REPORT FOR ACTION

Front Yard Parking Appeal – 15 Highview Crescent

Date: August 11, 2017
To: Etobicoke York Community Council
From: Manager, Right of Way Management, Transportation Services Toronto and East York District
Wards: Ward 17 - Davenport

ATTACHMENT ' A '
STREET LINE
1.60 (SURVEY)
2.1
GARAGE
5.02
2.4
ASPHALT DRIVEWAY
BAY WINDOW
.62
No. 15
HIGHVIEW CRESCENT
10.5
GRASS
1.6
1.4
1.4
2.8
ENTRANCE
BAY WINDOW
CONCRETE SIDEWALK
STREET LINE

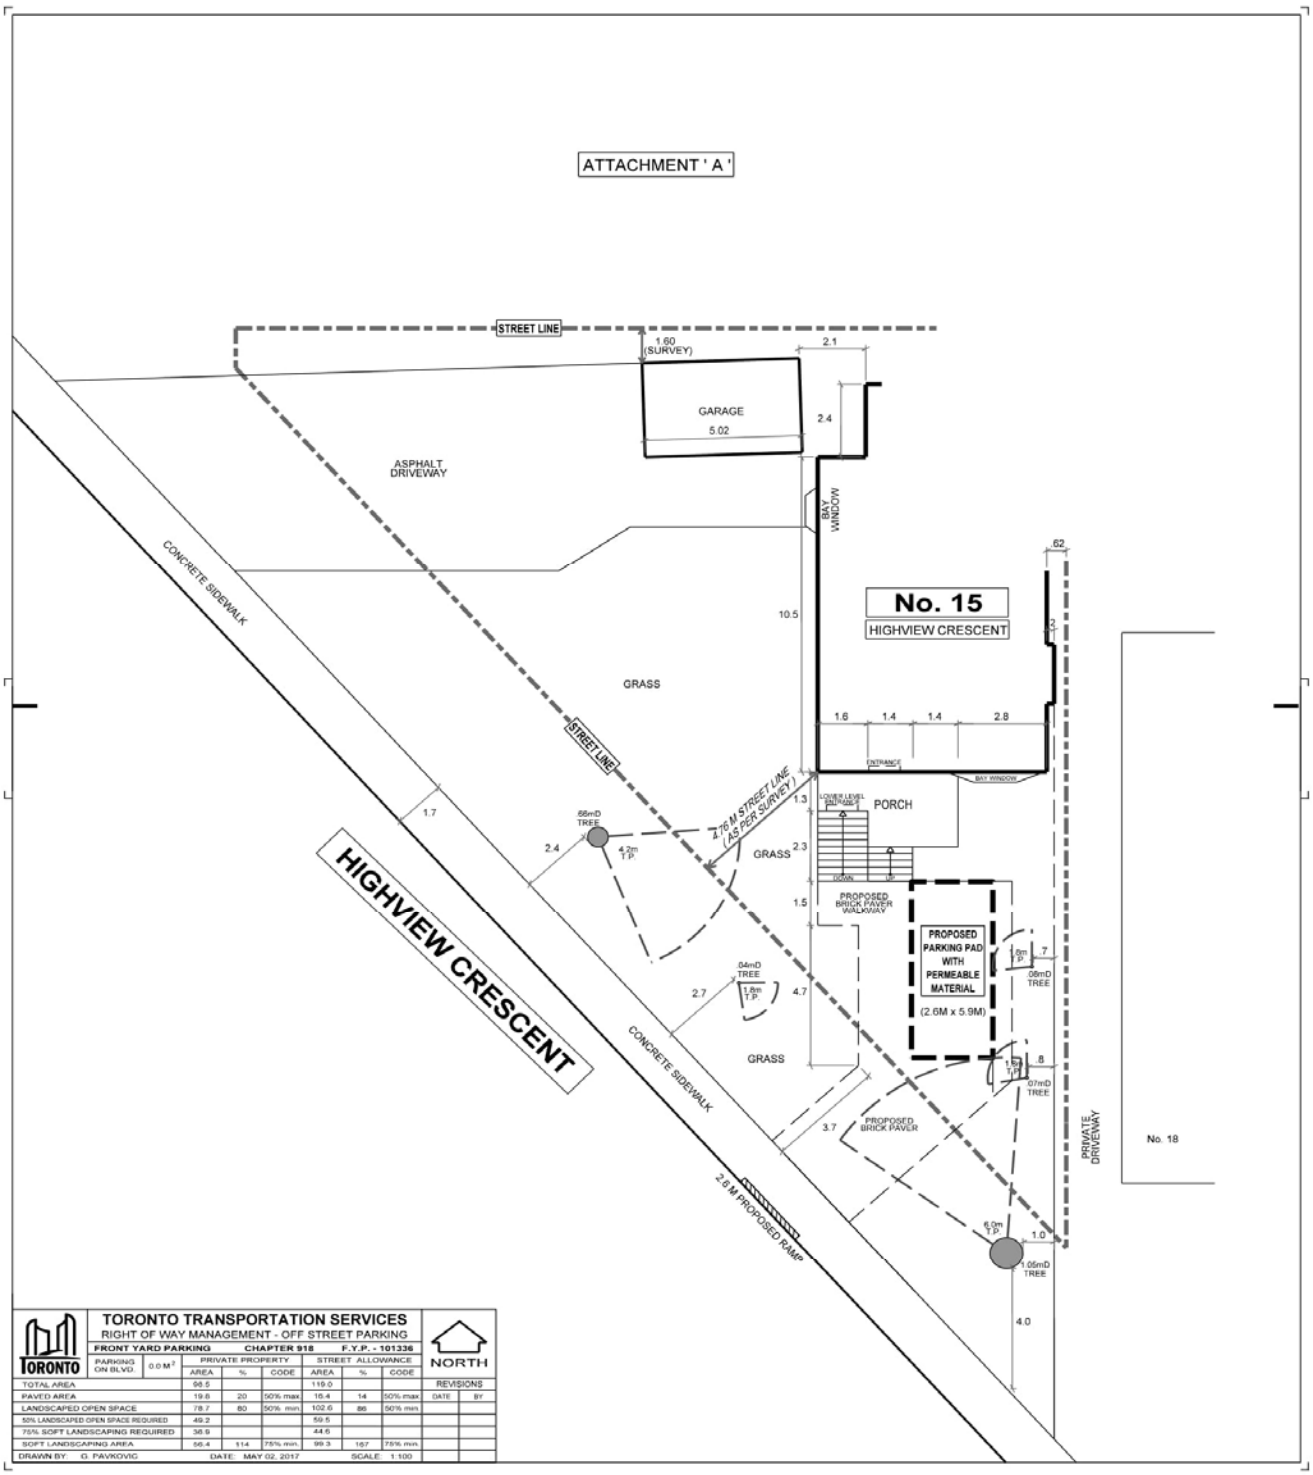
- the property is serviced by a private driveway to a single garage; and
- a portion of the driveway required to access the proposed parking pad does not provide the required clearance from the existing tree.

There is a tree fronting this location which is in close proximity to the driveway that would be required to access the parking space. A review of this application by Urban Forestry has determined that the proposal has a negative impact to the tree in question and Urban Forestry would not support the proposal. There is no suitable planting site for an additional tree.

1. the parking area be a minimum of 2.2 metres in width and not exceed 2.6 metres and a minimum of 5.3 metres and not exceed 5.9 metres in length;

2. the applicant pay for the installation of the permanent ramp to service the parking space;

3. The applicant contacting Urban Forestry and to comply with any and all requirements in accordance with the City of Toronto Tree Protection Policy and Specification for Construction Near Trees as construction is proposed near or within the tree protection zone;

5. the applicant provide the landscape features substantially in accordance with the plan as indicated in Attachment 'A', attached to the report dated August 11, 2017, from the Manager, Right of Way Management, Transportation Services, to the satisfaction of the General Manager of Transportation Services; and
